MASSACHUSETTS DEPARTMENT OF TRANSPORTATION HIGHWAY DIVISION

SPRINGFIELD MCKNIGHT COMMUNITY TRAIL			
STATE	FED. AID PROJ. NO.	SHEET NO.	TOTAL SHEETS
MA	-	1	66
PROJECT FILE NO.		608157

PLAN AND PROFILE OF MCKNIGHT COMMUNITY TRAIL

25% SUBMITTAL

CONSTRUCTION PLANS & PROFILES

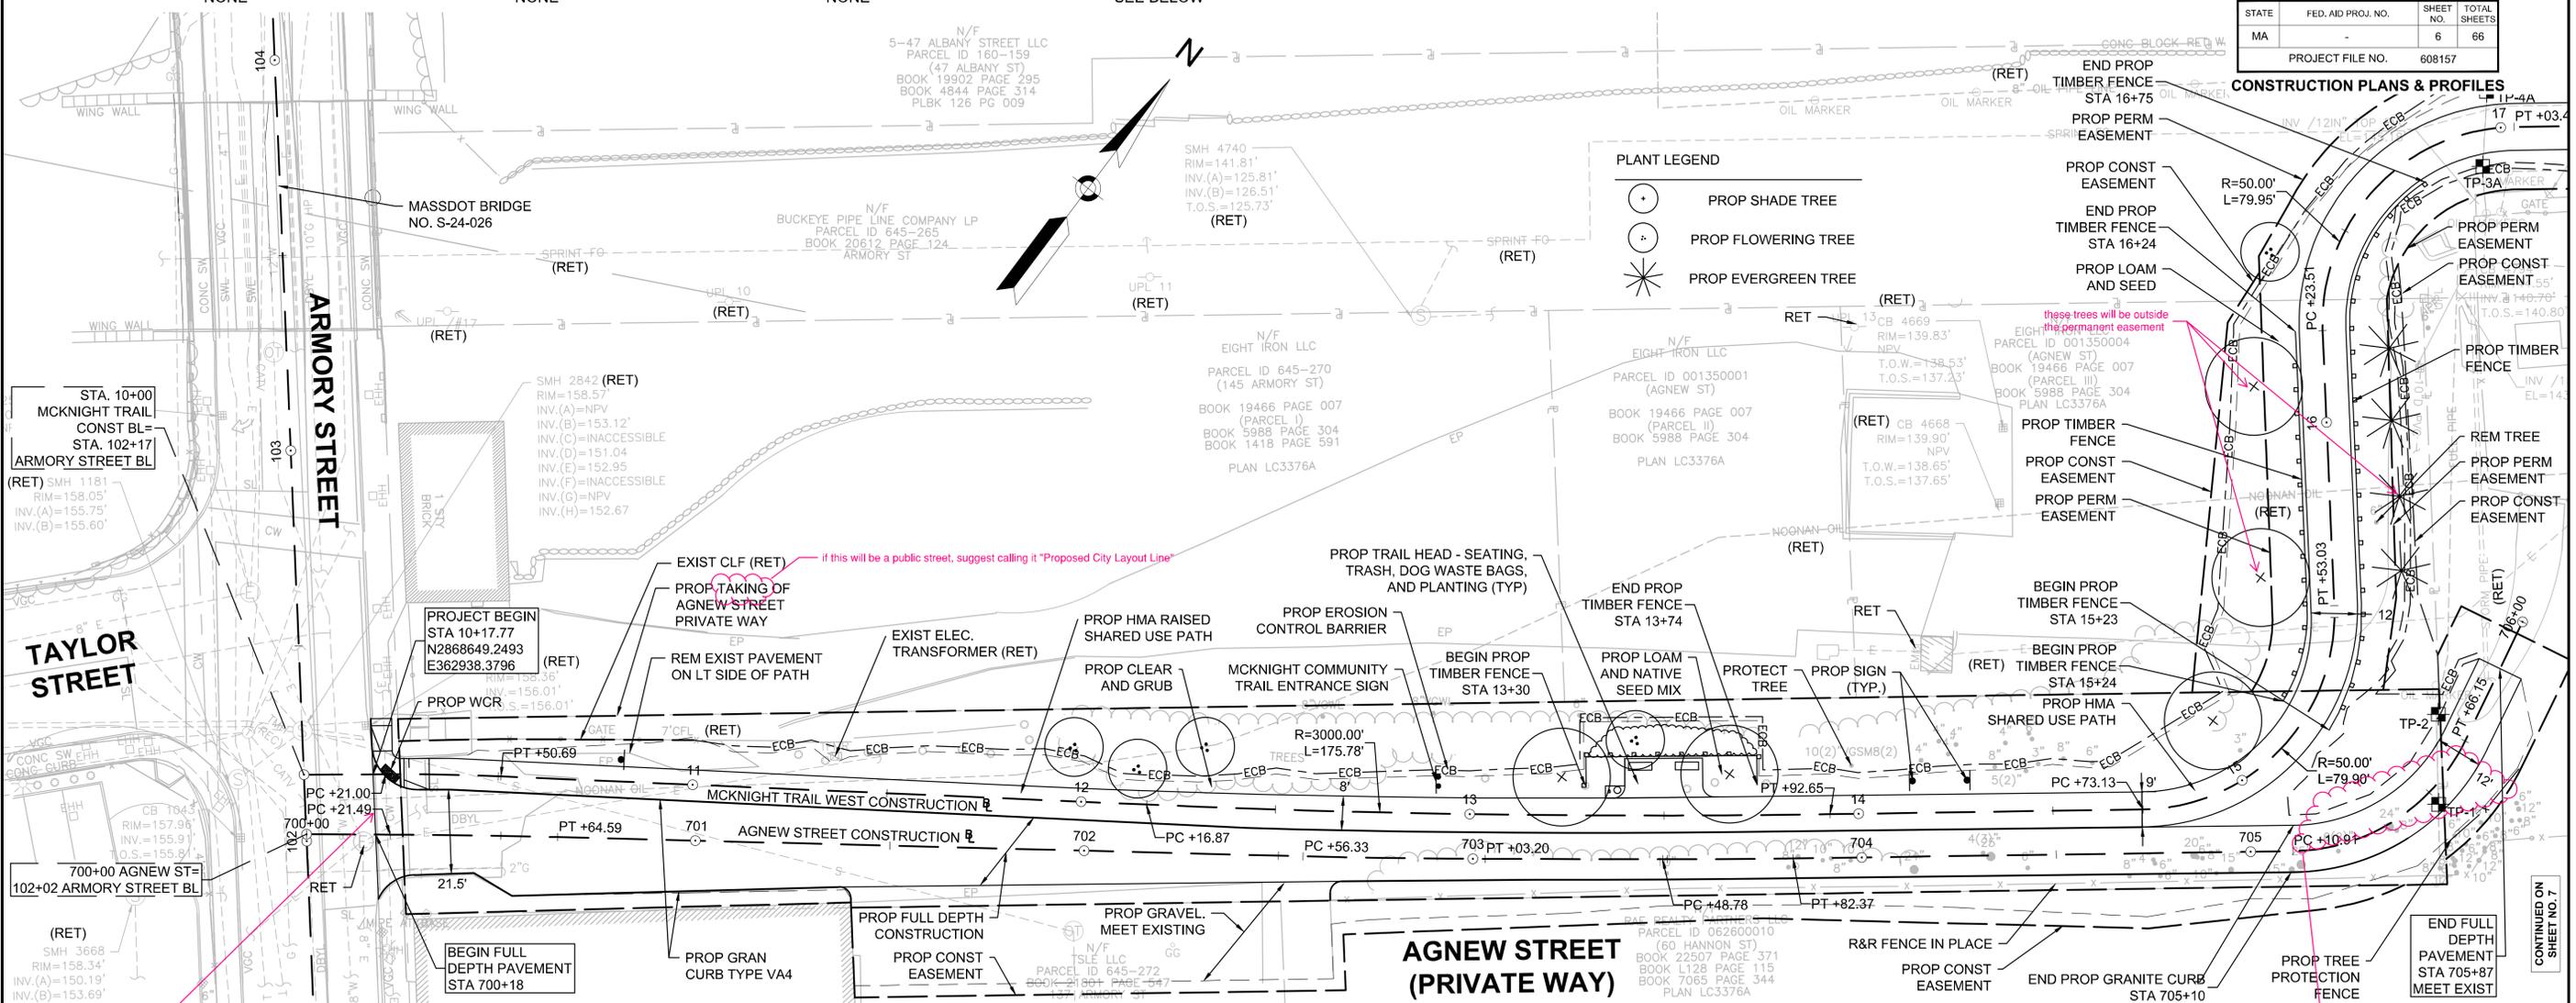
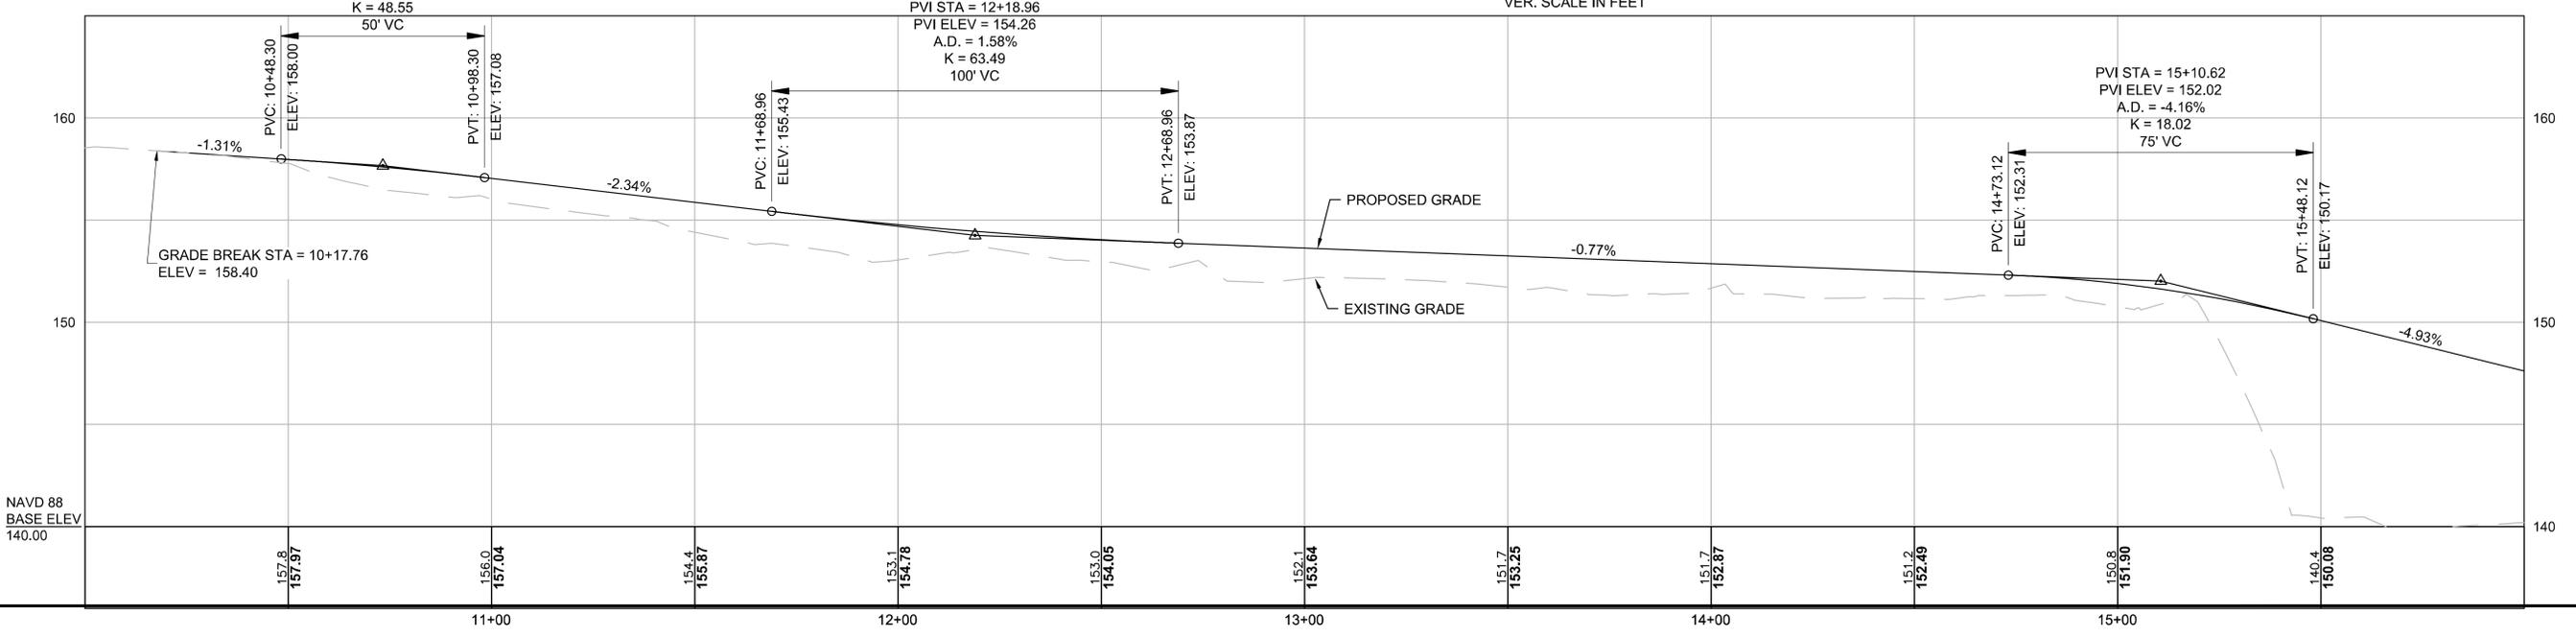
This project abuts future bridge replacement project 609409 with an ad date of 11-9-2024. It doesn't look like there is direct conflict with the work, but if the two projects happen at the same time coordination between Contractors will be required.

There are existing washouts here in the private gravel driveway from water running down the unpaved access road. Based on this it looks like drainage will need to be intercepted along the proposed Agnew Street to prevent runoff from causing problems at the bottom of the hill.

CONSTRUCTION PLANS & PROFILES

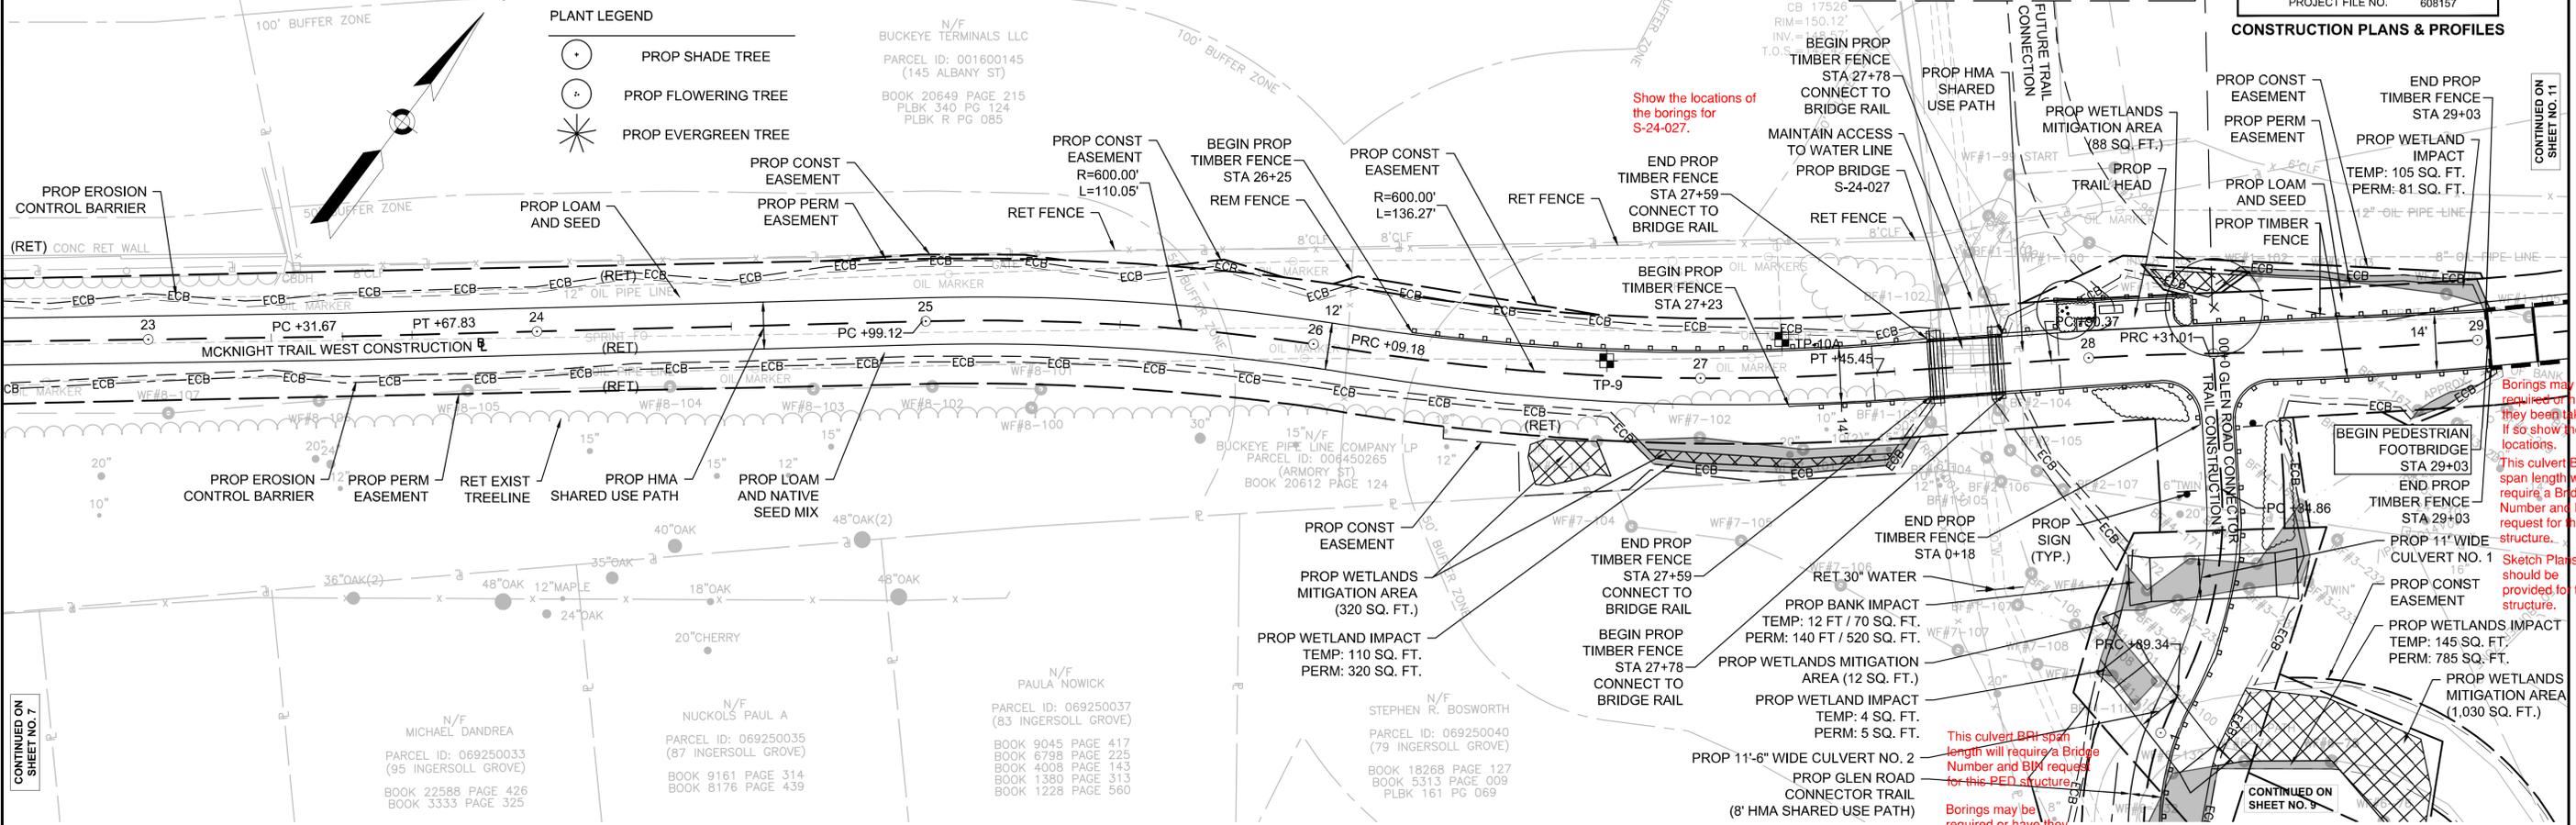
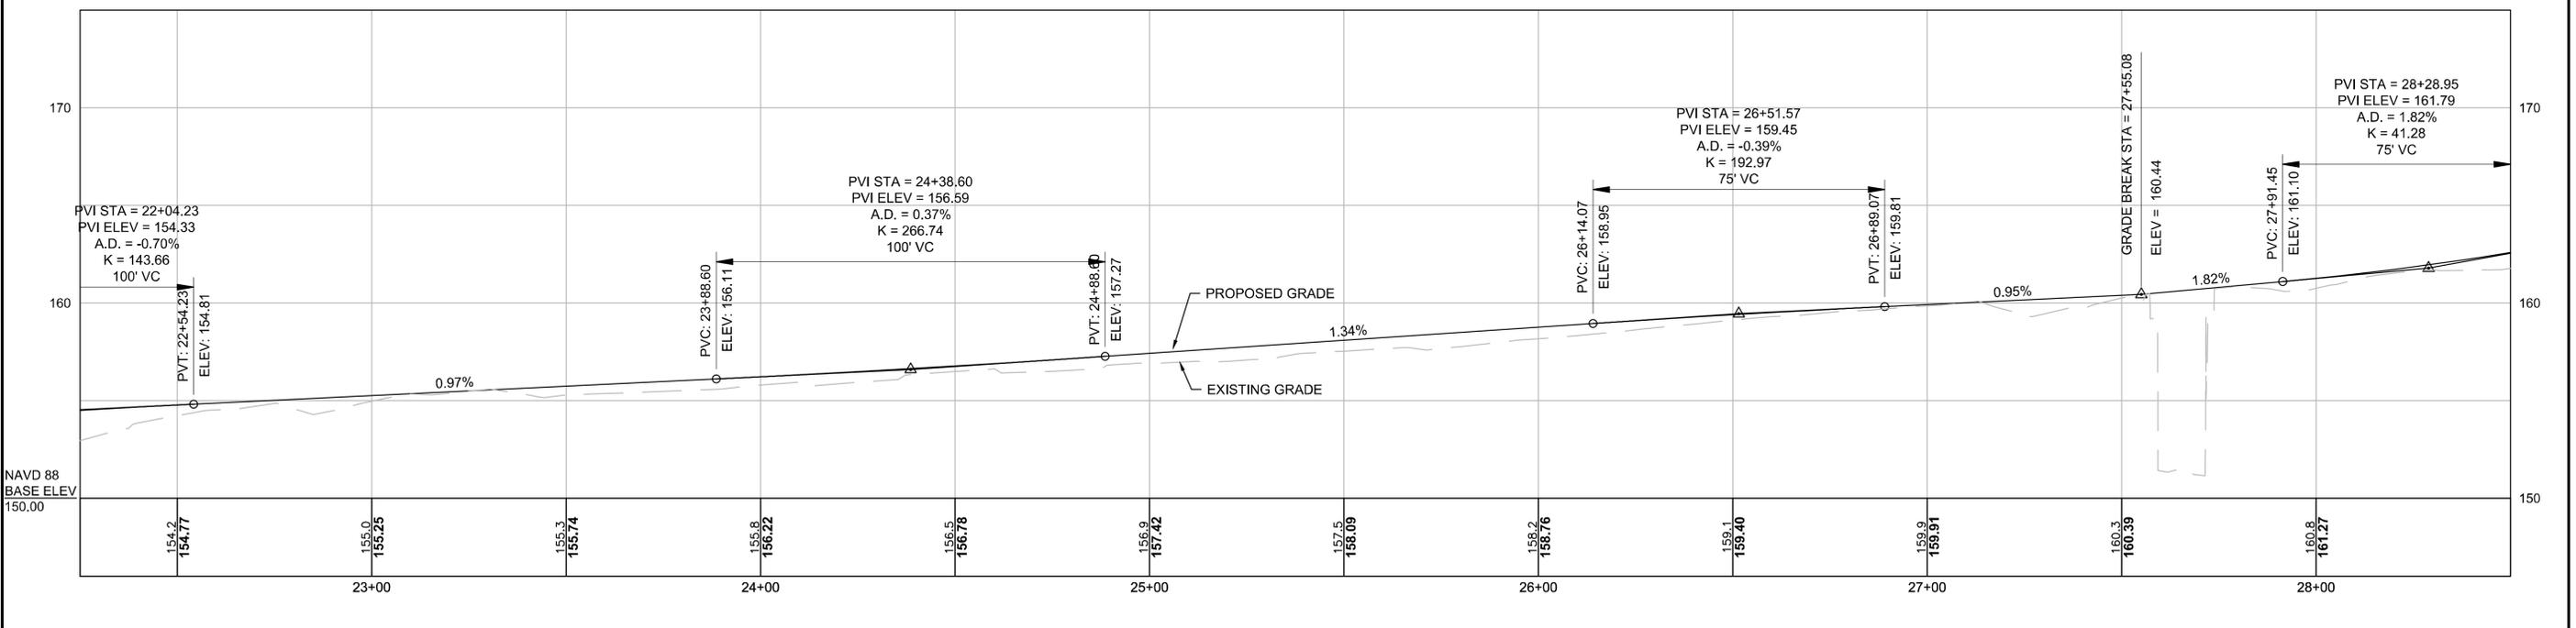
Show the locations of the borings for S-24-027.

Borings may be required or have they been taken? If so show the locations.

This culvert BRL span length will require a Bridge Number and BIN request for this PED structure.

Borings may be required or have they been taken? If so show the locations.

Sketch Plans should be provided for this structure.

Are hydraulic and geotechnical reports required for these two culverts?
